Southern California Edison Company

Subject: Docket Nos. 50-361 and 50-362
San Onofre Nuclear Generating Station, Units 2 and 3

ATTACHMENT I

EVALUATION
OF
POST-WELD HEAT TREATMENT PROCESSES

Figure D-6. VERTICAL PIPE ENDS NOT BLOCKED 30F/INCH

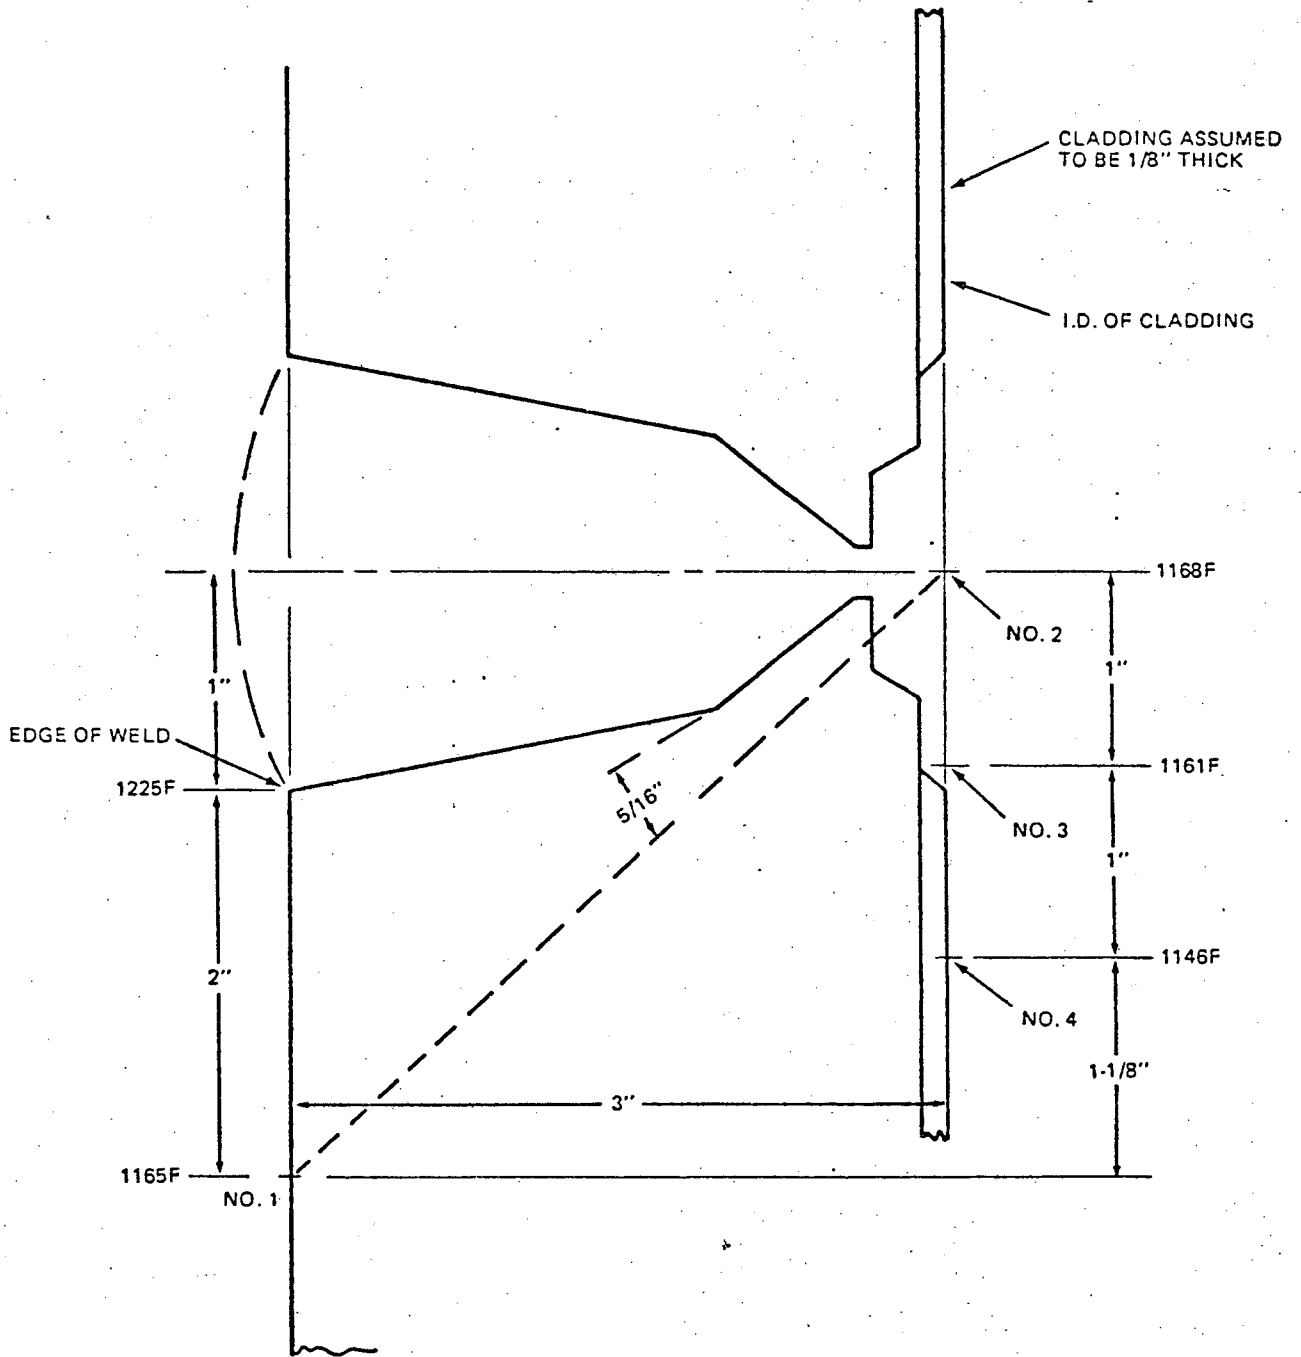
Contrary to the above, as of February 5, 1979, the post weld heat treating procedure using the quartz lamp technique had not been qualified before use to demonstrate that the minimum heat treating temperature of 1100°F, a design requirement, was met during the post weld heat treatment of main steam piping and reactor coolant piping welds. This procedure had been used since mid-1977 for heat treating the aforementioned welds at Units 2 and 3.

Figures D-1 through D-4 and D-5 through D-8 are in Appendix 4D and show the predicted inside pipe diameter temperatures for outside pipe diameter temperature gradients of 40, 30, 20 and 10F per inch. Outside pipe temperature gradients of 20 and 30F per inch are usually encountered in production welds. The 10 and 40F per inch gradients were modeled to bound the analysis. The pipe modeled had a 3-inch wall thickness, was in a vertical configuration, and had ends both blocked and unblocked. In all cases, a 10F/inch outside gradient yielded the lowest internal temperature. This configuration would yield the largest through-wall temperature gradients. With a reference temperature 2 inches from the weld edge of 1165F, the lowest internal temperature, 1 inch from the weld centerline (outside heat affected zone), calculated was 1138F with pipe ends unblocked. This is a maximum through-wall temperature gradient of 37F and confirms that the 3-inch and smaller wall thickness pipes are acceptable since these pipes were all heat treated at reference temperatures at least 40F above the required temperature. The effect of not blocking the ends of the pipe is an increase in the through-wall temperature gradient of 6F for the 3-inch wall thickness vertical piping.

The computer model predicted a temperature difference of minus 27F between the control thermocouple on a 3-inch thick vertical axis pipe and the internal weld centerline. The installation test data from Appendix C showed this temperature difference on a 3-3/8 inch thick (compared to 3-inch thick) vertical axis pipe to be 35F. This shows good correlation considering the thicker wall pipe, the difference in thermocouple placement, and the accuracy of the recorders. The good correlation justifies use of the program to predict the internal temperatures on thicker pipe.
